**Rail Central:**

Phase 2a:

Localised Consultation –  
plans pack for consultation

# Updated draft parameters plan

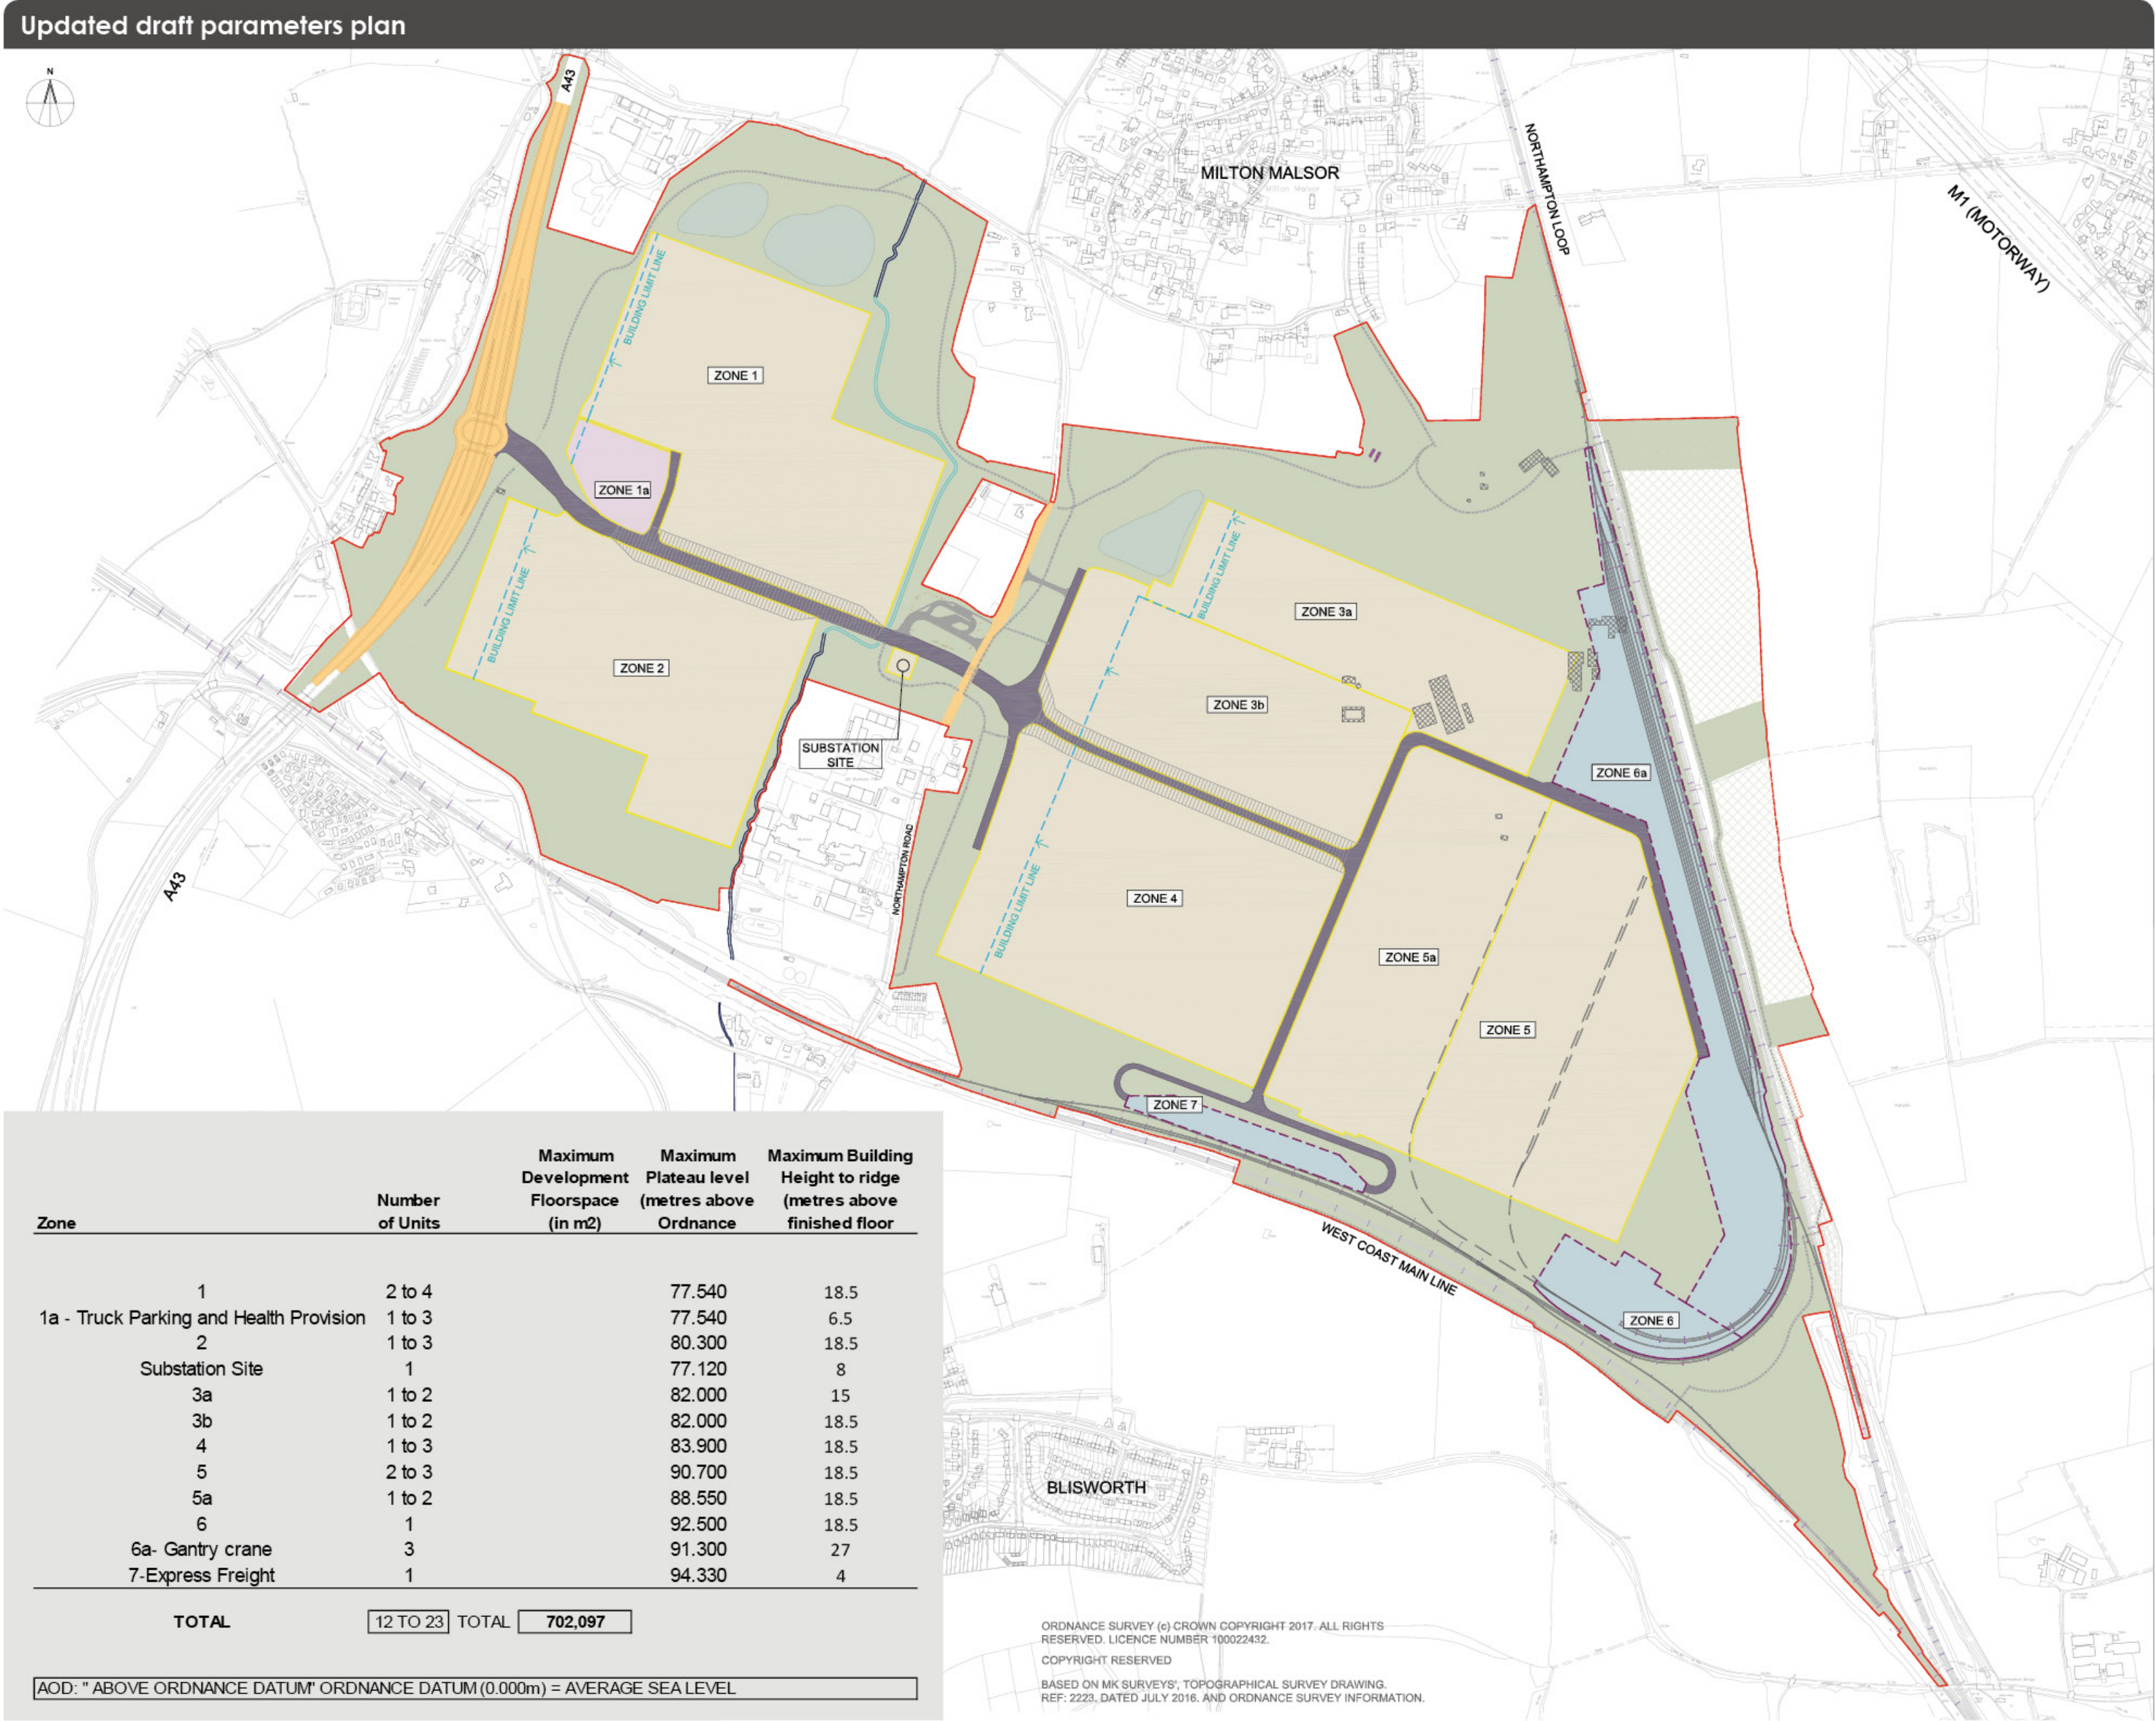
- A minor amendment to the development zones as shown in the parameters plan, which now enable the zones to directly abut the proposed internal estate roads, providing flexibility for access to the individual units;
- A minor realignment of the main access from the A43 into the site;
- Zone 3 as previously shown on the Parameters Plan has now been split in to Zones 3a and 3b. We have reduced the maximum building heights within Zone 3a (to the north) from 18.5m to 15m. This is a direct response to concerns raised at Stage Two Consultation regarding visual impact;

- An amendment to the landscape bunds in a direct response to concerns raised at Stage Two Consultation regarding visual impact. The proposals are to:
  - Raise the bund to the north of Zone 1 by 2m and extending it to the north;

- Raise the bund to the north of Zone 3a by 2m, excluding at the northern tip where it remains as before;
  - Reduce the ground levels in Zone 3a and 3b by 0.5m, and in Zone 4 by 0.35m;

- The relocation of the “building limit” line within Zone 3a. This has been moved slightly, 48m to the west, to allow additional flexibility as to the future detailed design of the proposed warehousing;

- Introducing a zone of flexibility on sections of the main site spine road, both to the east and west of Northampton Road. This zone extends to 20m either side of the current central alignment of the spine road within the site and will provide the necessary flexibility for delivering an alternative alignment at detailed design stage;

# Updated draft highways 'red line' plans: the Order Limits A5076 / A5123 / Upton Way roundabout – potential improvements

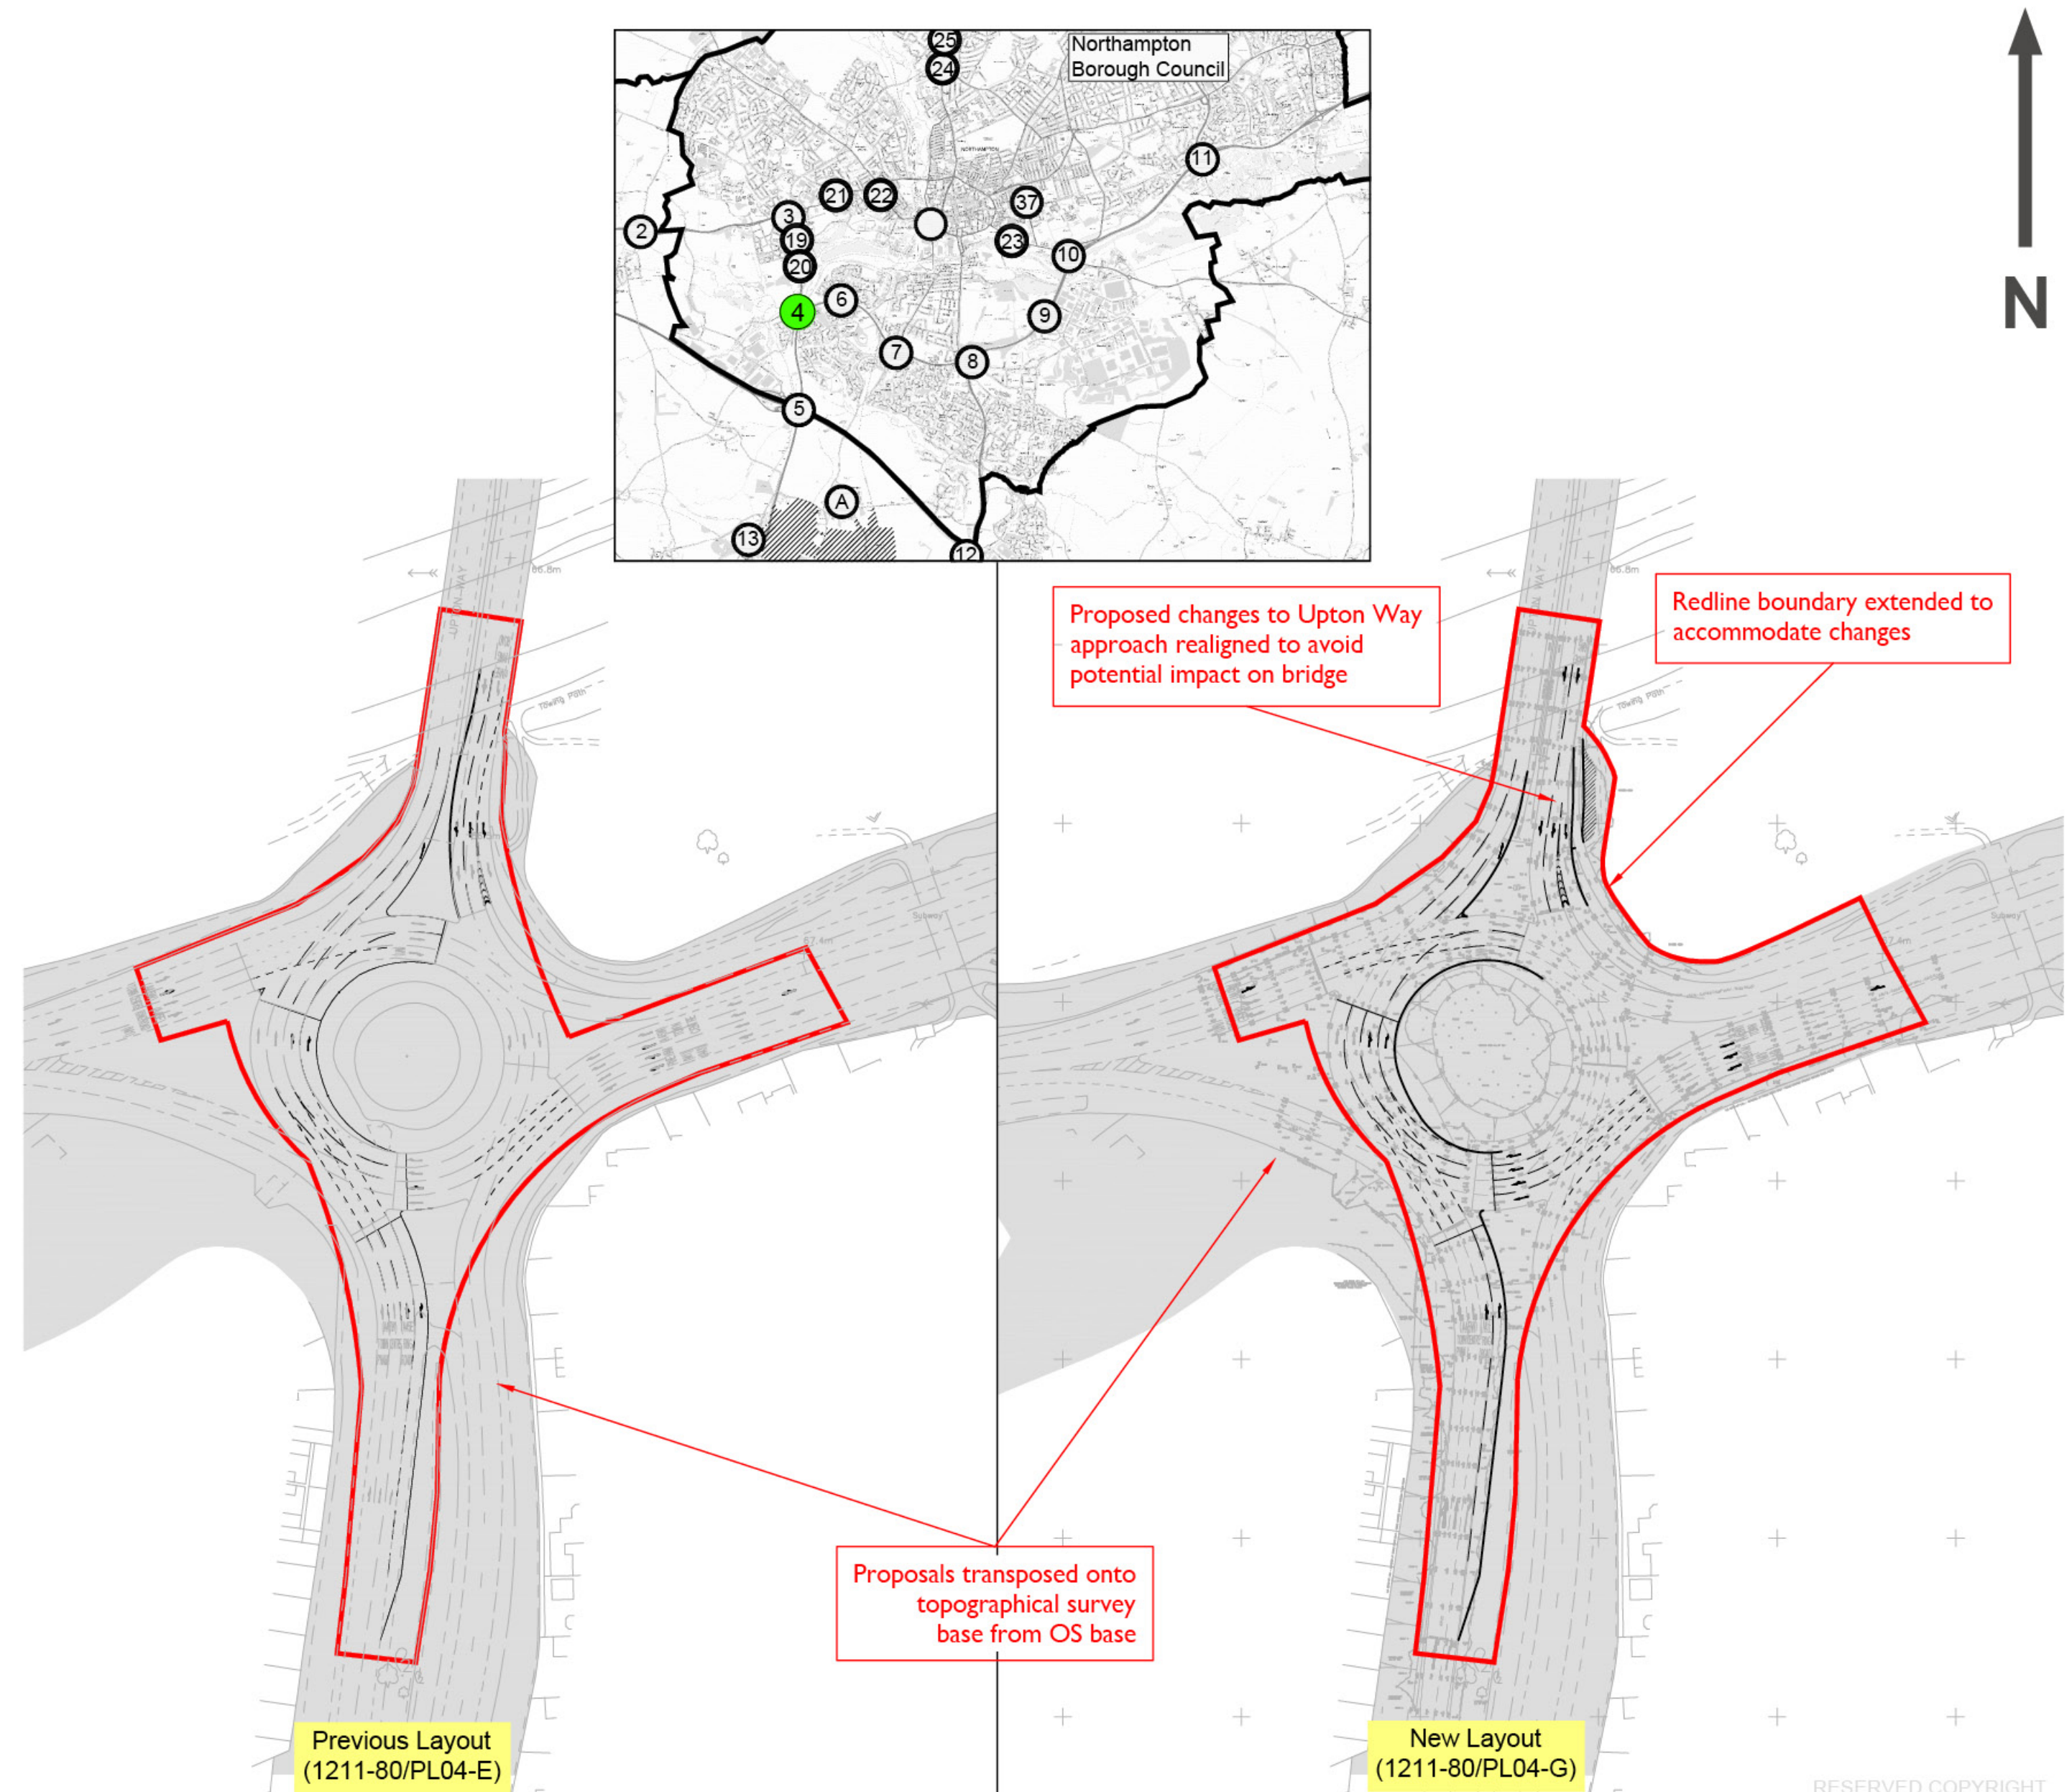
- A5076 / Upton Way: this extension will allow for the approach road and left turn slip lane to be realigned, avoiding any impact on the bridge. The extension will be entirely within existing highway land, owned by Highways England.
